## Addendum #I - SCUSD - Abraham Lincoln ES - Fencing and Shade Structure

ABRAHAM LINCOLN ELEMENTARY SCHOOL - FENCING & PC SHADE STRUCTURE

ISSUED		
MARK	DATE	DESCRIPTION
DSA	04/09/2025	DSA APPROVAL
ADD 01	05/05/2025	ADD 01

**DEMOLITION PLAN**

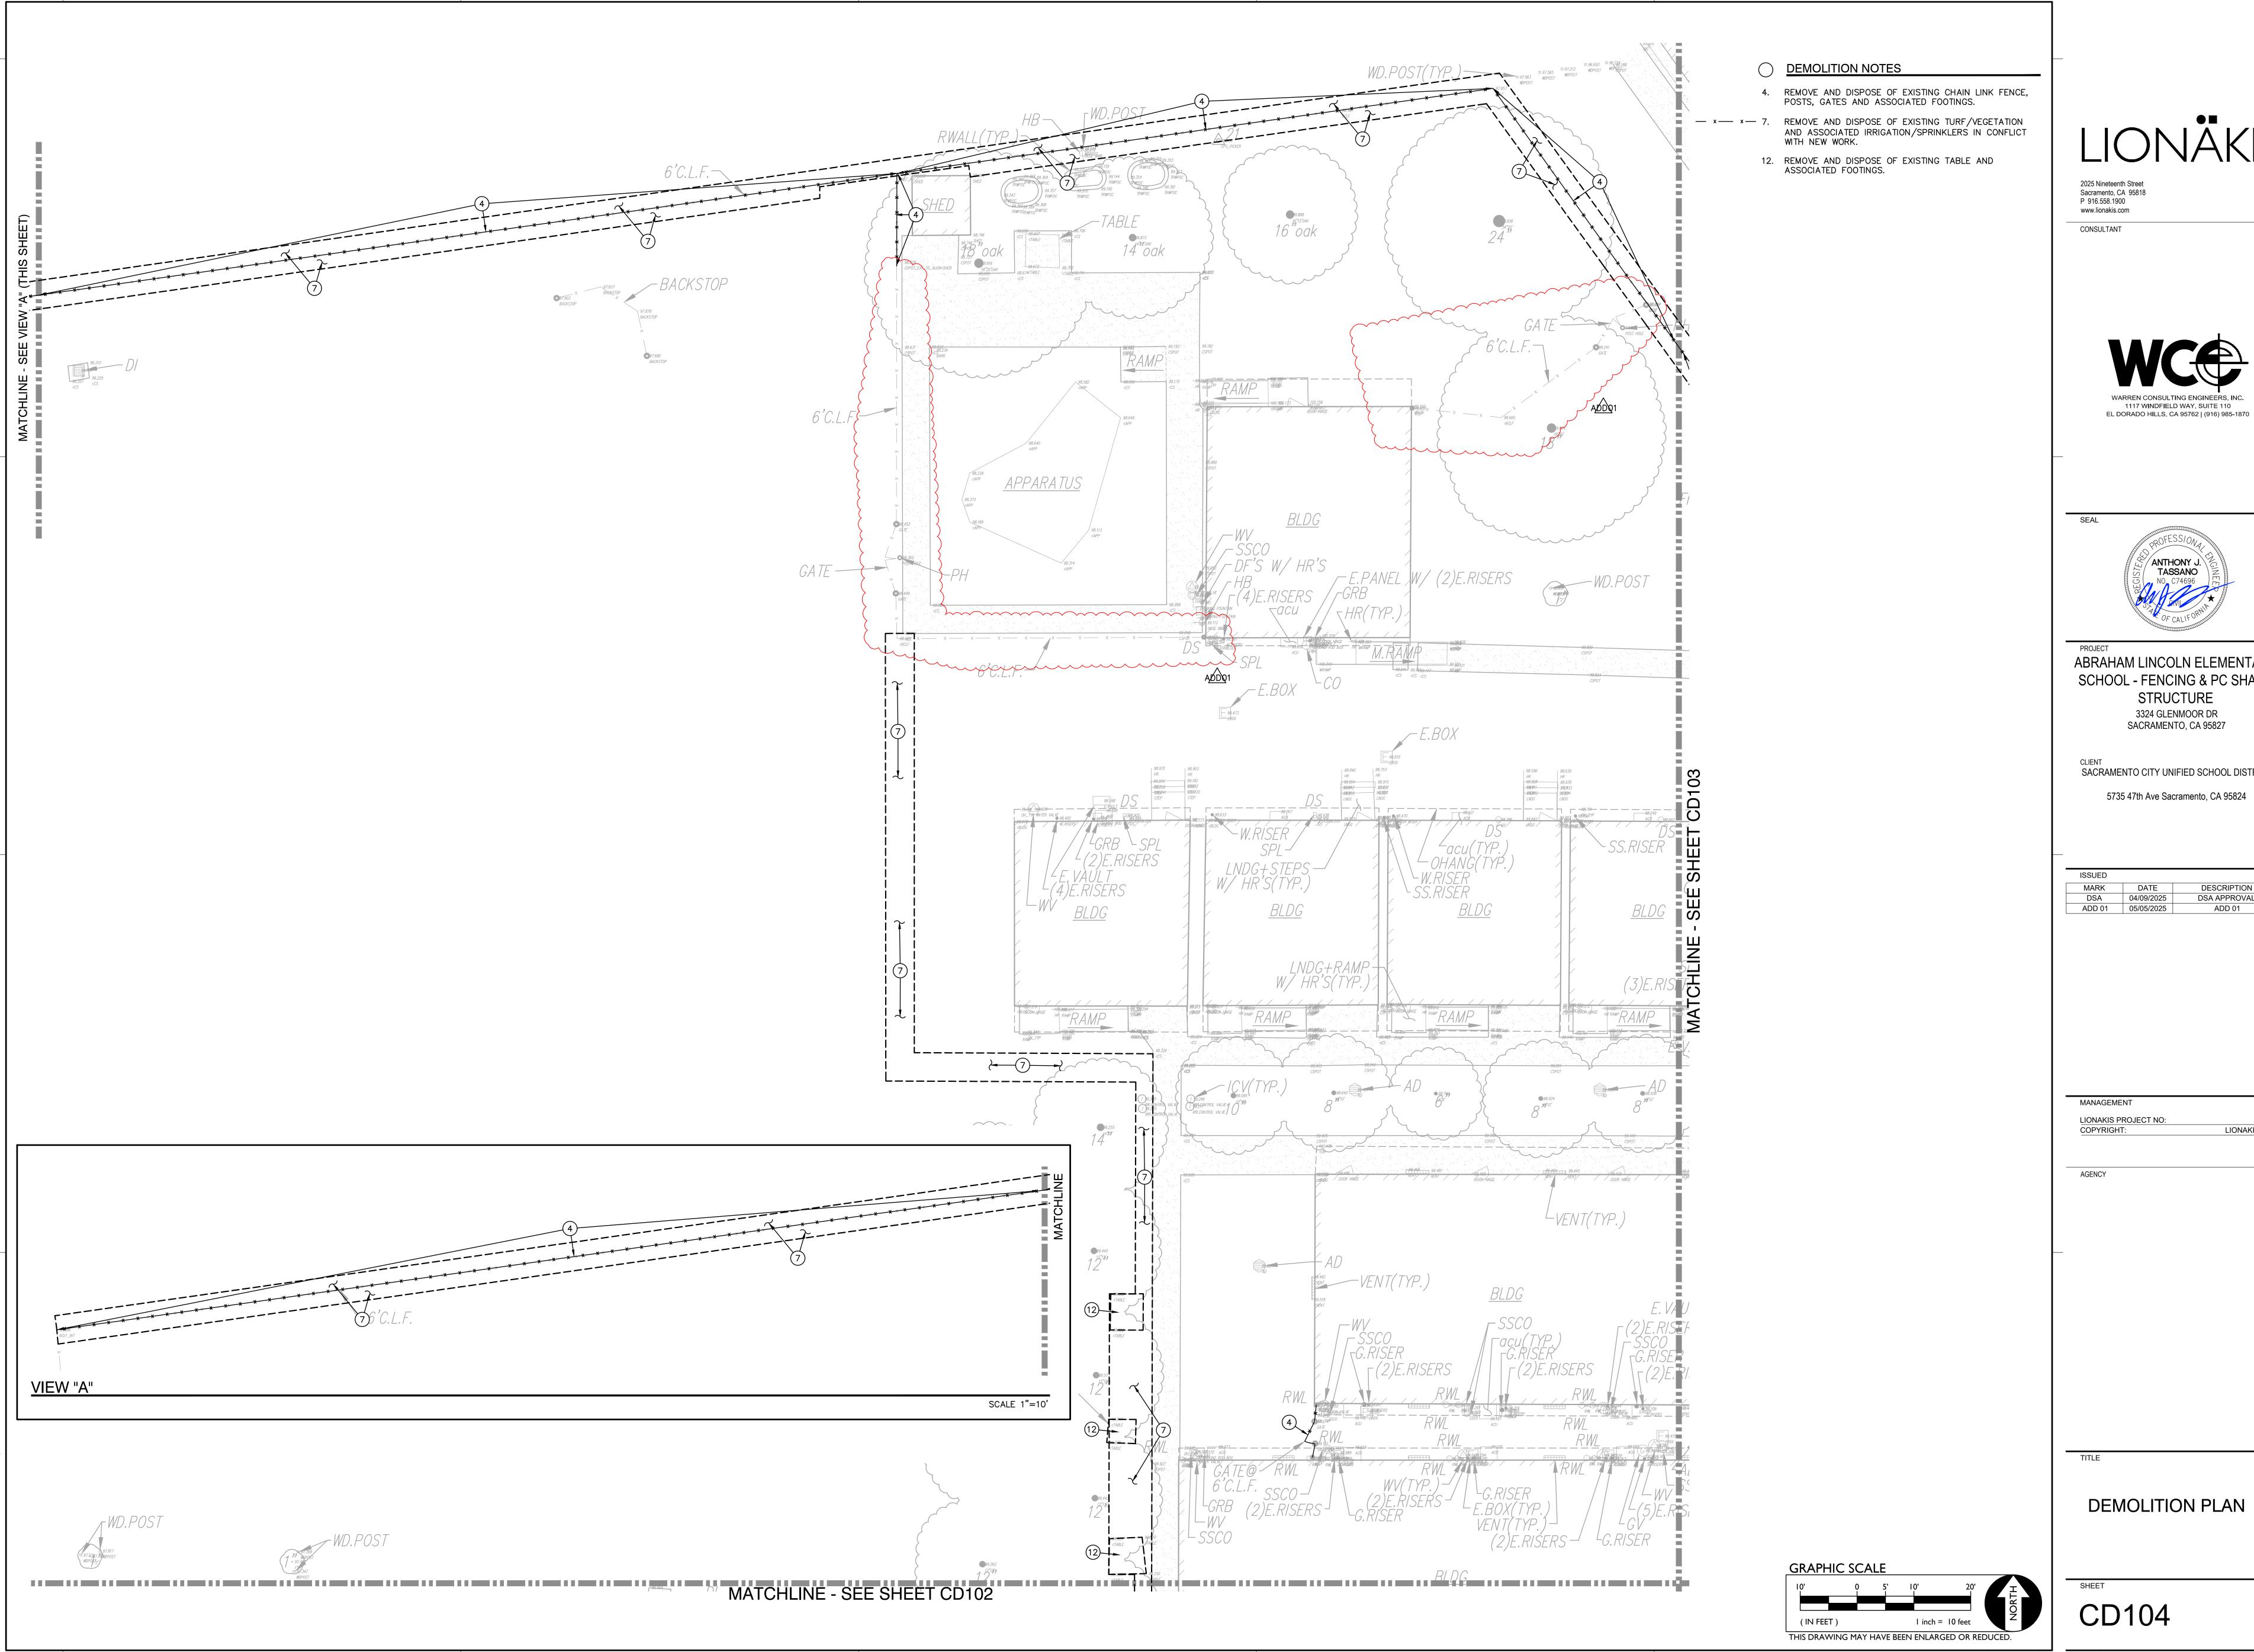
- CD101
  - o Call out added for Bollard Demolition
- CD104
  - o Removed Scope of work near north portable to match architectural drawings
- CG102
  - o Sheet revised to show grading plan
- CGI03
  - o Removed concrete scope of work at existing backflow preventer
- CGI04
  - o Removed Scope of work near north portable to match architectural drawings
- CPI01
  - o Removed concrete scope of work at existing backflow preventer
- C501
  - o Detail 8 revised to include nosing as specified
  - o Railing call out for painting to match arch plans

AS101

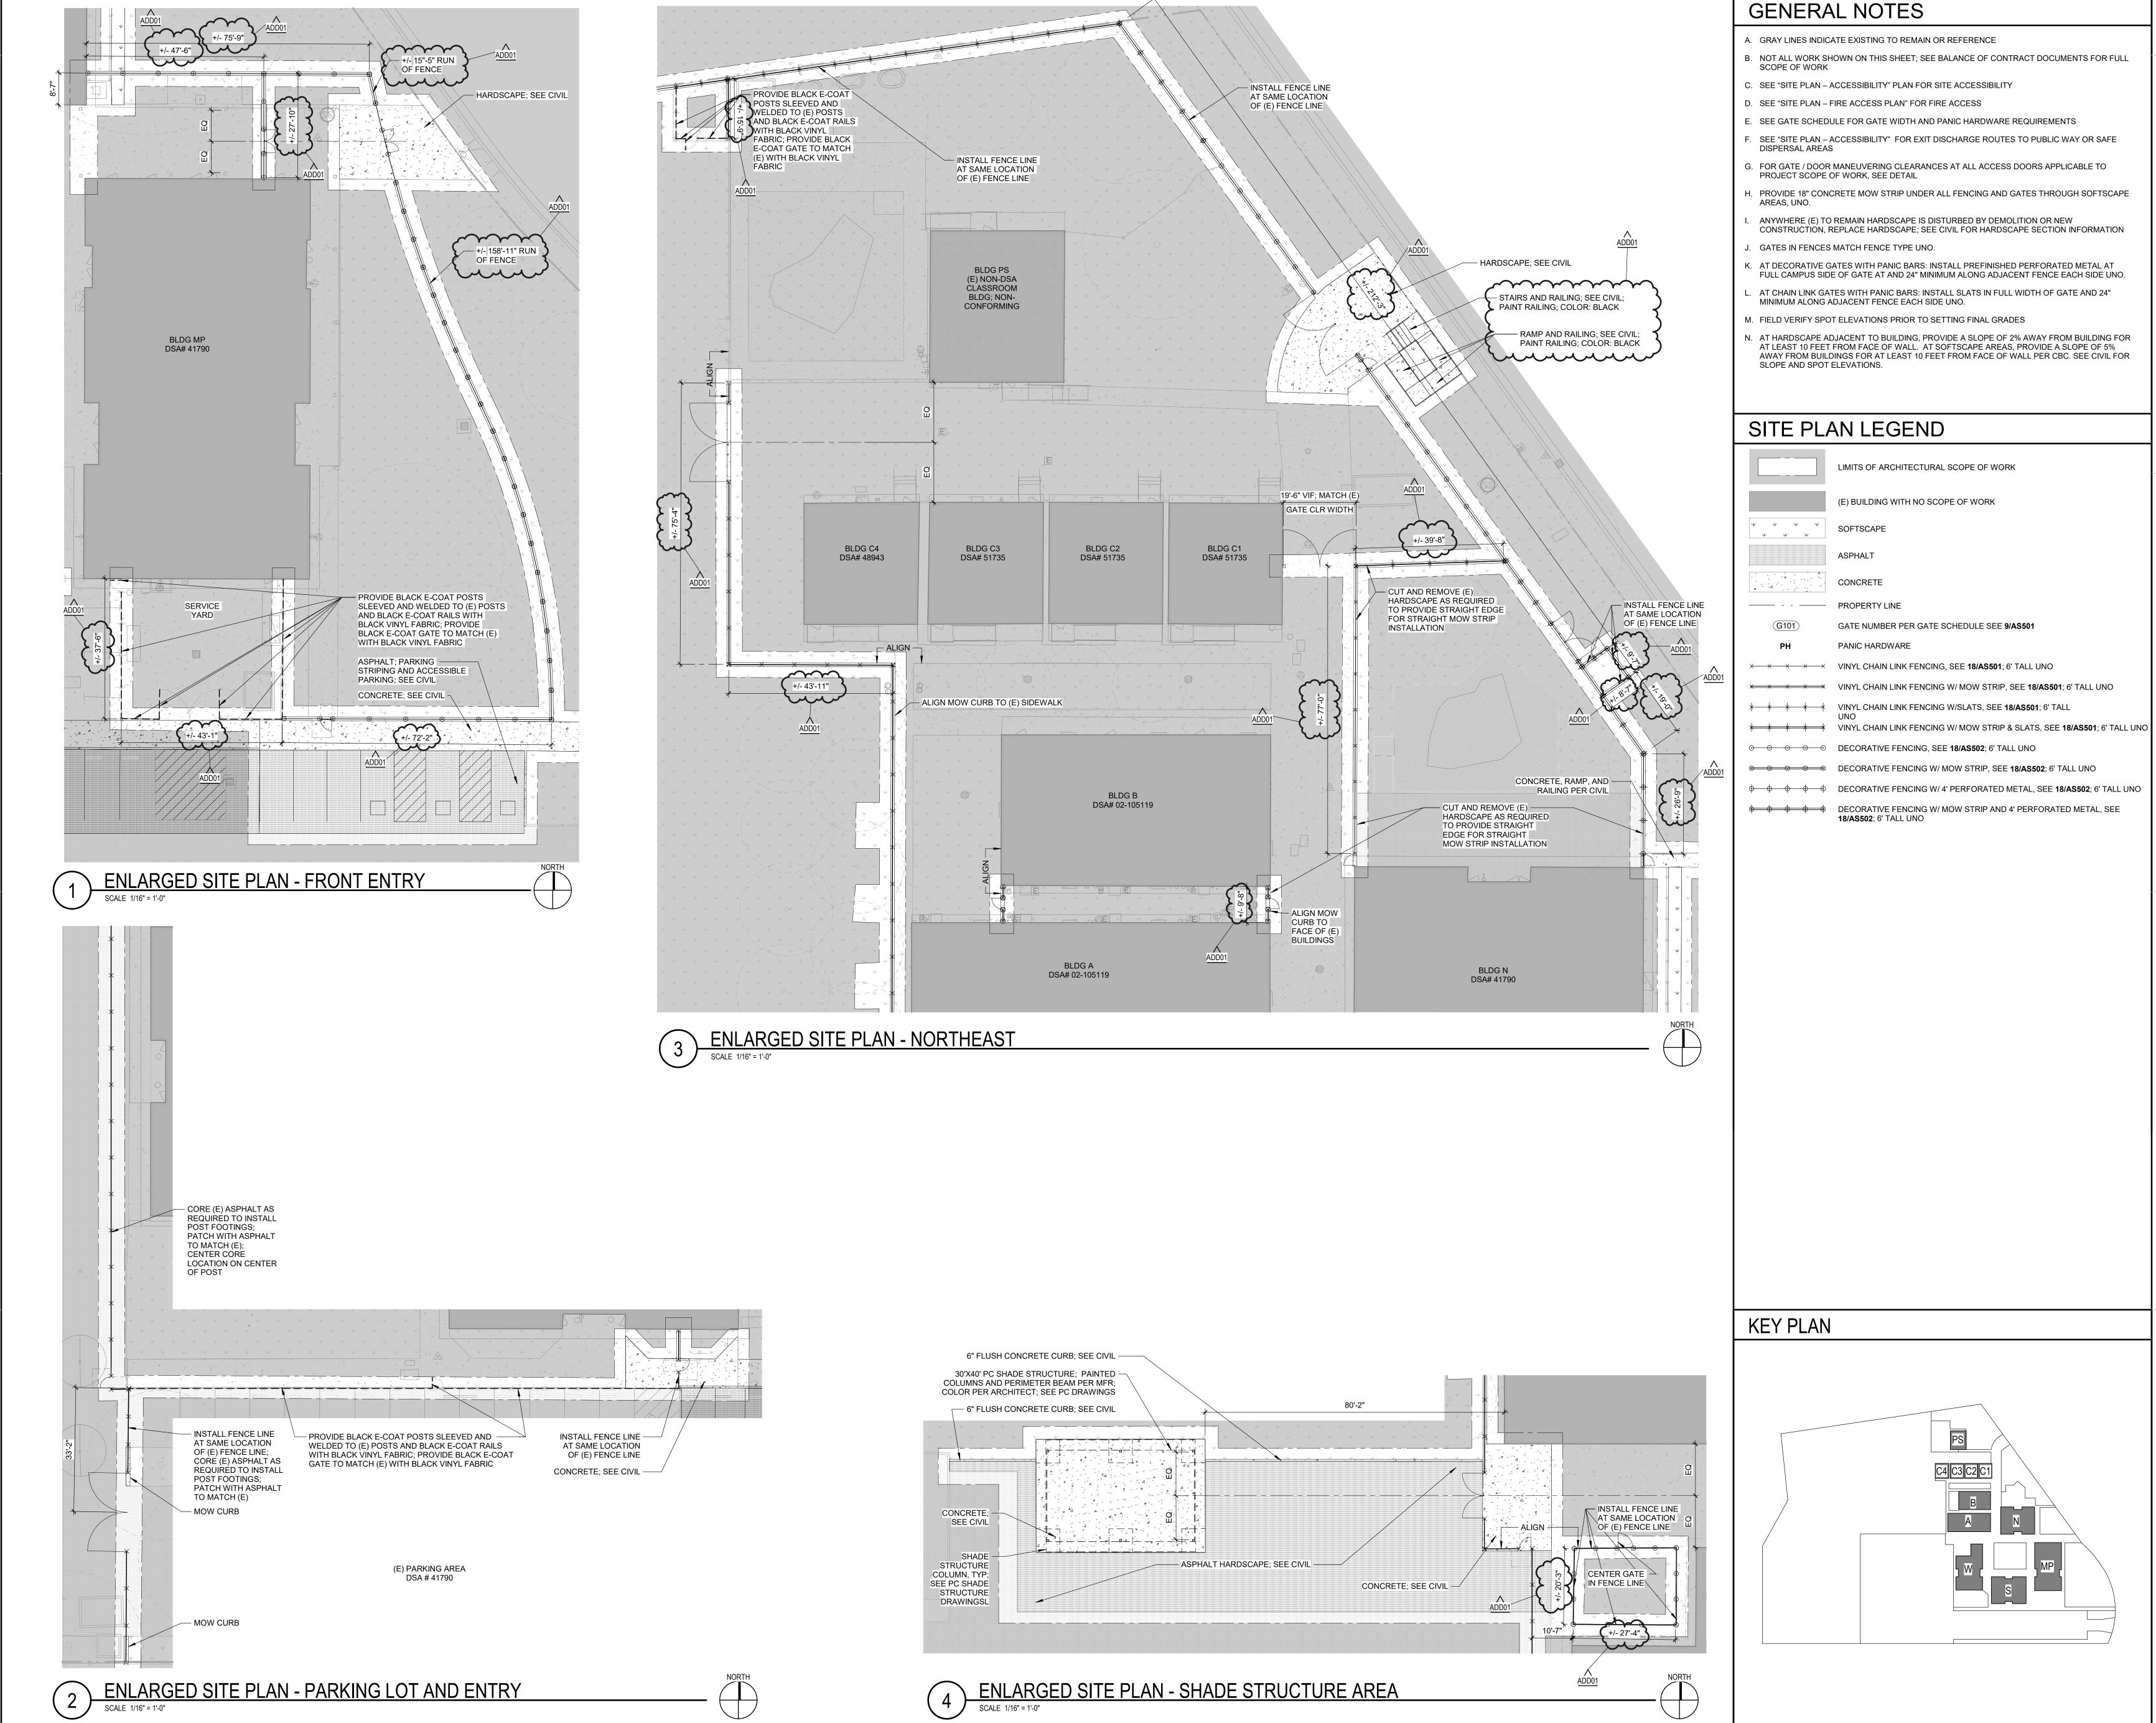
- ASI01
  - o Add Alt #1 info
  - o Revisions to scope of work at gate S021 and associated fence
  - Dimension Clarifications
- AS102
  - o Dimension Clarifications
  - o Call out added for paint at railing at stairs and ramp added
- AS501
  - o Hardware revisions
  - o Added post requirement at S001 and S022
  - o Astragal Clarifications
- AS502
  - o Perforated metal clarifications on fence and gate details
